Technical Service Bulletin

87D9 UPDATE – AC Pressure/Temperature Sensor (NVLW)

October 14, 2014

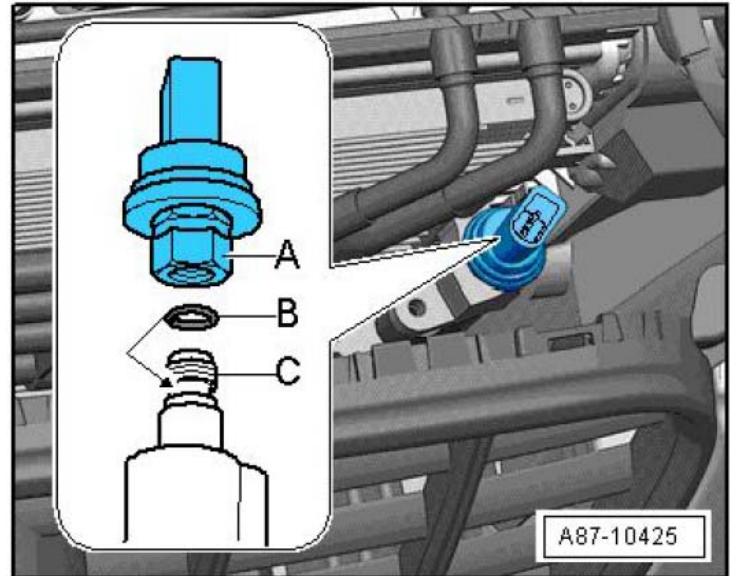
1. Remove the refrigerant pressure sensor -G395- <A> by following the instruction in ElsaPro >> Repair Manual >> Heating, Ventilation and Air Conditioning >> 87 Air Conditioning >> Removal and Installation >> A/C Pressure/Temperature Sensor G395.

2. Check production date of sensor.

Example: 3 13612

3: Shift
1: Day
36: Week
12: Year (2012)

- Replace sensor **ONLY** if the last 4 or 5 numbers are:

- 3212
- 3312
- 3412
- 3512
- 3612
- 3712
- 3812
- 3912
- 54612

- If the sensor date is not within these ranges reinstall sensor with new o-ring, PN 7H0820896.
